Project Order Modification (P.O.M.) #01 for Project Order 107

PROJECT NAME:	MIA - Terminal H FL2 Area A - Smoke Evacuation System (U023A)	PROJECT ORDER No:	107
CONTRACT TITLE:	Miscellaneous Construction Contracts, MCC-8-10	DATE:	01/21/2021
CONTRACTOR:	MCM Corporation	PAGES:	66

DESCRIPTION OF WORK: This is an excusable non-compensable Project Order Modification (POM) extending the contract time to completion by an additional 121 calendar days.

REQUEST FOR WORK ORDER/PROJECT ORDER MODIFICATION #3

Exhibit No. 3 – Impacted Schedule with delays

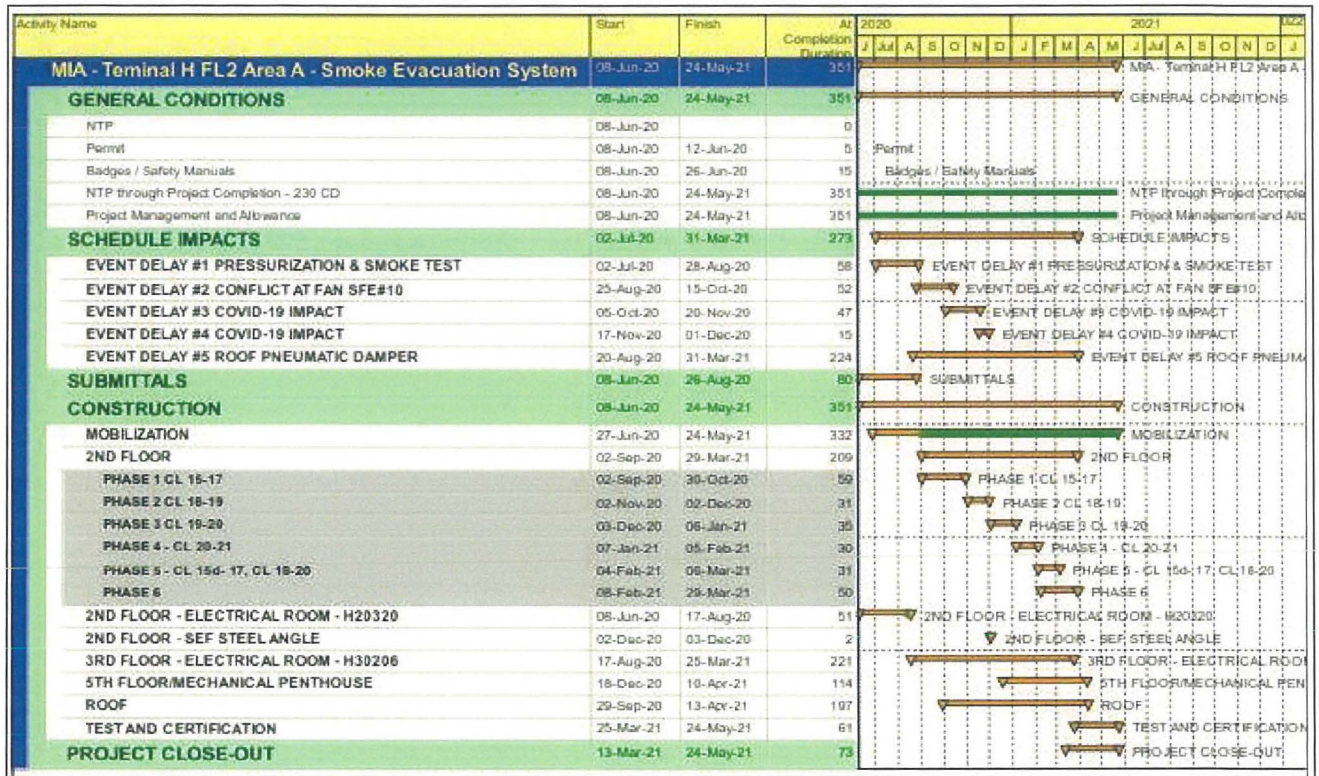
The impacted updated schedule below, reflects how the substantial completion date has been impacted as a result of the events described in this report. In this analysis, each delay has been added to the updated schedule as a single event and its effects.

This time analysis is to request a time extension due to various unforeseen conditions extending the project completion to May 24th, 2021.

ACTUATOR INFORMATION

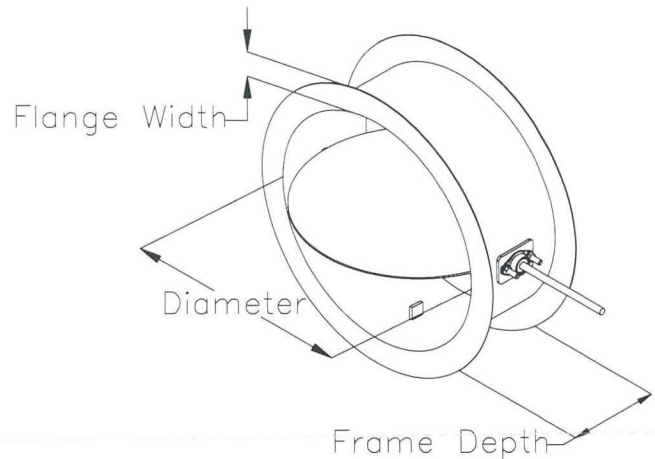
- A change from the originally submitted exhaust duct damper was required (from electrically operated to pneumatically operated). This unforeseen change required a re-submittal of the damper specifications and a delay in the ordering of the damper.

On 8/20/20, The Mechanical Subcontractor (Gamma Air Systems) submitted RFI #SES-06, requesting clarification (Type, model, Manufacture) for Motorized damper at rooftop gridline. The mechanical contractor was instructed to provide a quote with time and money impact for both damper systems: electrical and pneumatic. On 11/25/20, following Architect's suggestion, it was decided to install the pneumatic dampers. On 12/17/20, the Mechanical subcontractor provided the submittals to A/E for approval. The pneumatic damper is currently under review. Following approval, the lead time for material delivery is estimated for end of March 2021. (See Exhibit No.11)

Actuator Type Pneumatic
Actuator Mounting External
Actuator Fail Position Closed
Actuator Operation No Preference
Operating Mode Two Position
Supply Pressure 80
Auxiliary Switches 2
